Serial No. 10/779,758

Docket No. K-0604

Amdt. dated May 19, 2006

Reply to Office Action of December 19, 2005

FIG. 2  
Prior Art

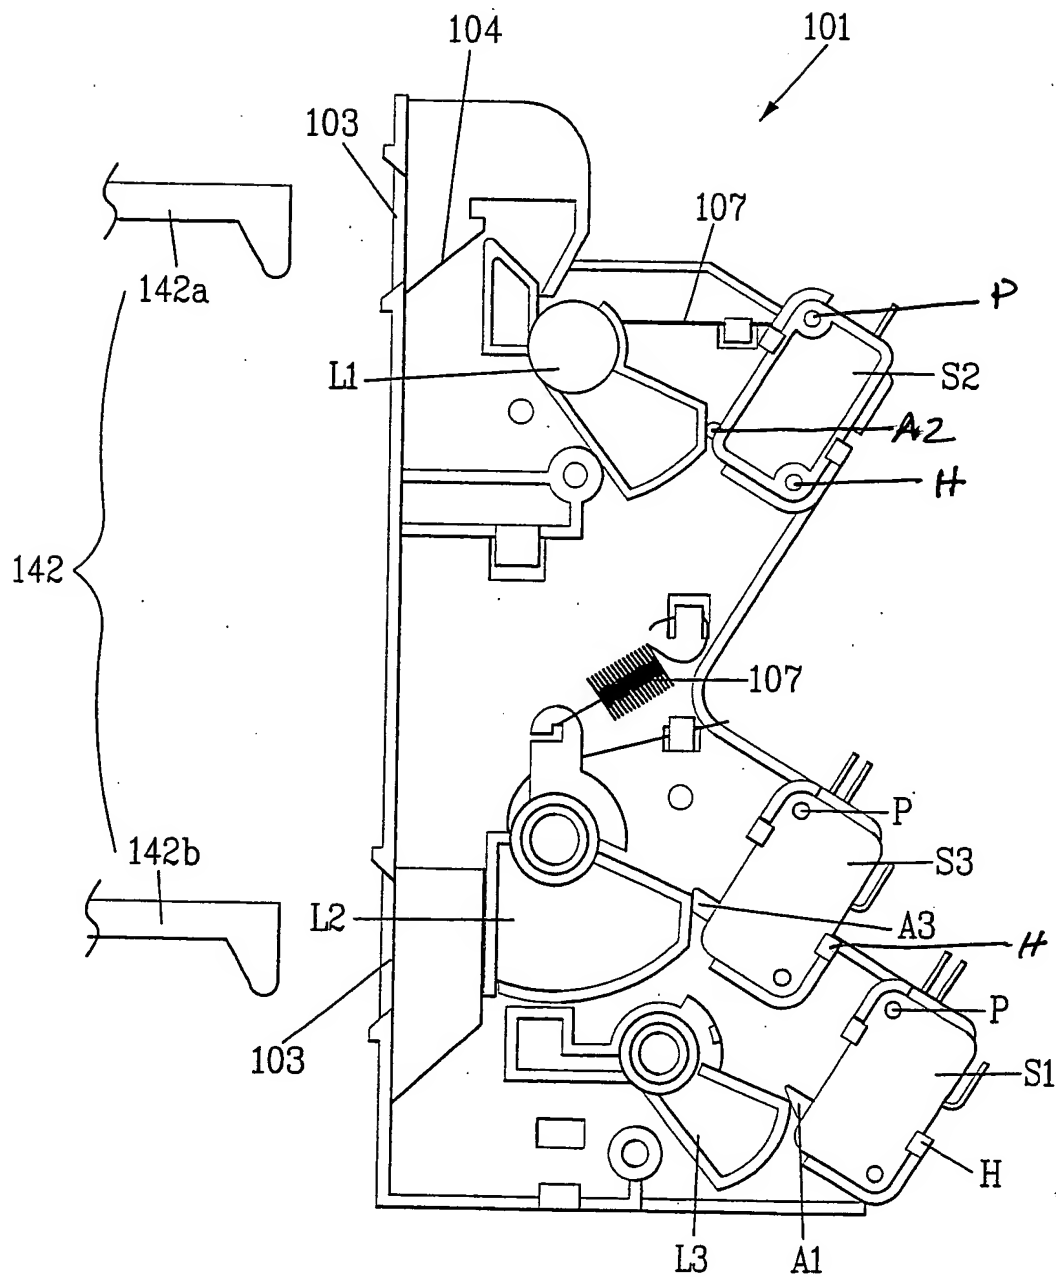
The attached drawings include changes to Figures 2, 3, 6 and 8. These sheets, which include Figures 2, 3, 6 and 8, replace the original sheets including Figures 2, 3, 6 and 8. Various reference numerals have been amended on Figures 2, 3, 6 and 8 to maintain consistency with the corresponding description thereof in the specification. No new matter is added.
